ADDENDUM NO. 1

RE: July 27, 2010 Rapid City Region Office Informal Letting – IM 0901(151)0, PCN 01MD – Lawrence, Meade & Pennington Counties – Replace Interstate Fencing

DETAIL FOR POST PANELS FOR SPECIAL RIGHT-OF-WAY FENCE

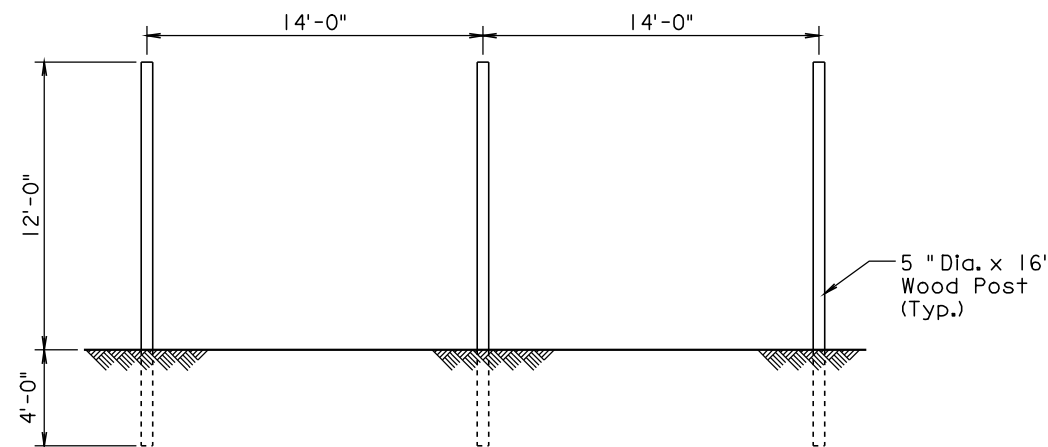
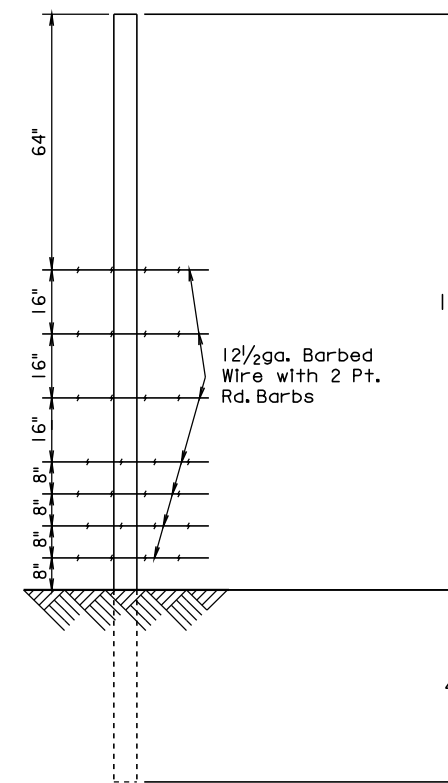
- Page 9 -Change pole dimension note from **6" Dia. X 16'-0"**to **6" Dia. X 18'-0"** at two locations to match drawing.
- Page 10 - Change note for Brace Rails from **(1 per brace)** to **(2 per brace)** at one location to match drawing.

Brace Posts 6" Diameter x 18' Length (2 per brace)
Pressure Treated, Pointed, Domed
Driven 4'

Brace Rails 5" x 10' (2 per Brace)
set at 3/4 Brace Height'
